Rezoning Transportation Analysis

Petition Number: 2019-115

Revision Log:

Date	Description
09-29-2019	First Review

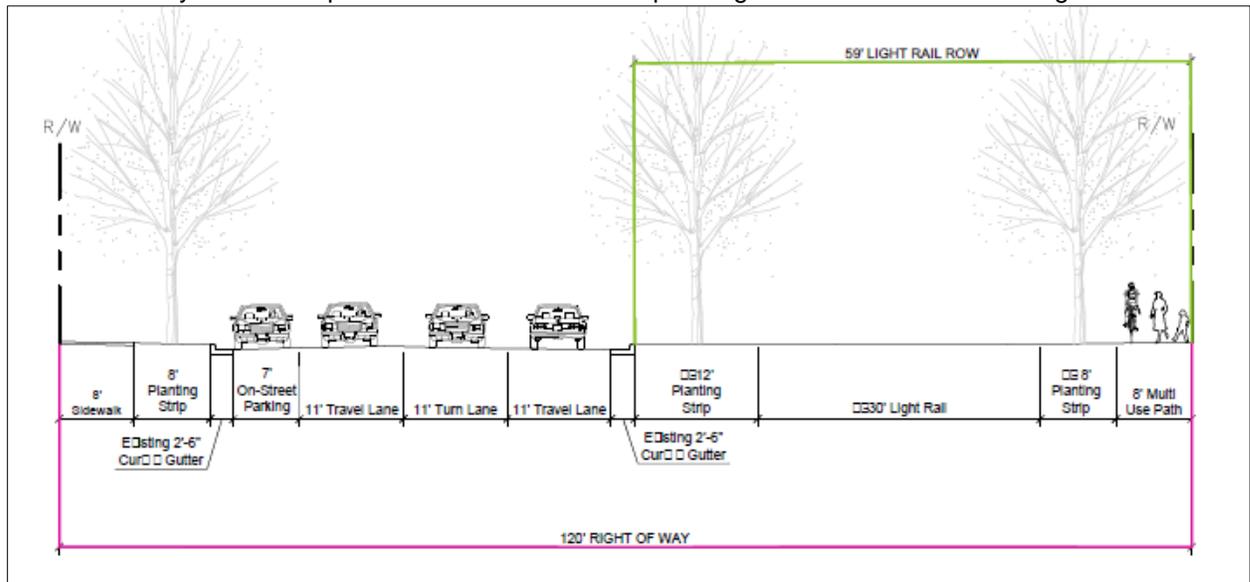
1. **Curbline** The proposed zoning district has a setback measured from back of the existing or proposed future curbline.
 - a. **Johnston Road/521:** Future curb and gutter will be determined by the future NCDOT US 521 project. US 521 is an NCDOT state maintained and controlled access facility.
 - b. **Ballantyne Commons Parkway:** The future location of curb and gutter is in its existing location.
 - c. **Ballantyne Corporate Place:** The future location of curb and gutter is in its existing location.

The site plan should show the curb and gutter labeled and dimensioned from the centerline for each road
